## **Technical Service Information**

## THM 3T40 (125C) NEW LOW/REVERSE CLUTCH RETURN SPRING AND SPIRAL RETAINING RING

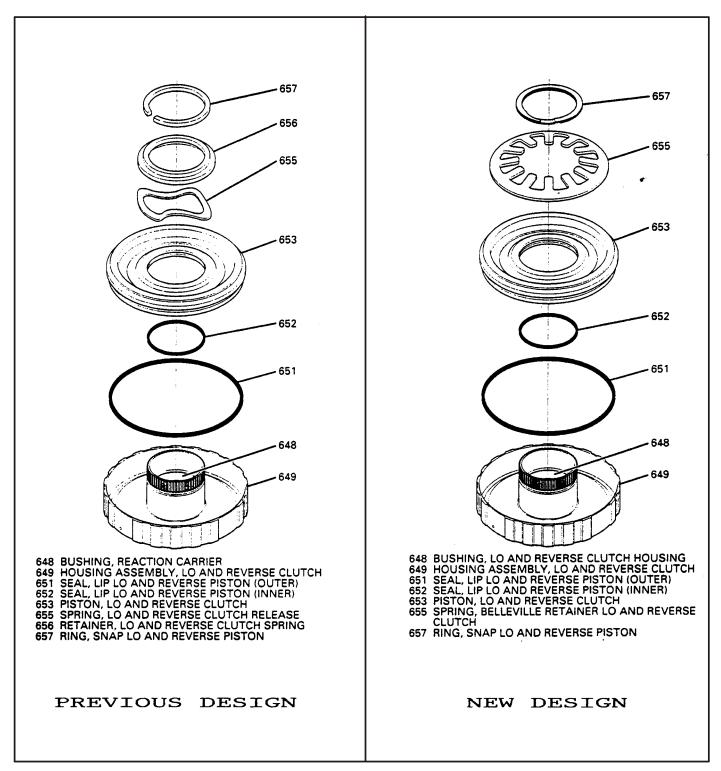
**CHANGE:** Beginning in 1993 models, there is a new "Belleville" return spring and spiral retaining ring

found in the low/reverse clutch housing. (See Figure 1).

The current return spring rate may not be great enough to keep the piston from partially

applying while in drive range.

(1) LOW/REVERSE RETURN SPRING - Changed to the "Belleville" design instead of the previous "Wave" design, and the spring retainer is eliminated. (See Figure 1).

(2) LOW/REVERSE RETAINING RING - Changed to a spiral retaining ring instead of the previous snap ring (See Figure 1). NOTE: NO CHANGES WERE MADE TO THE HOUSING OR PISTON.
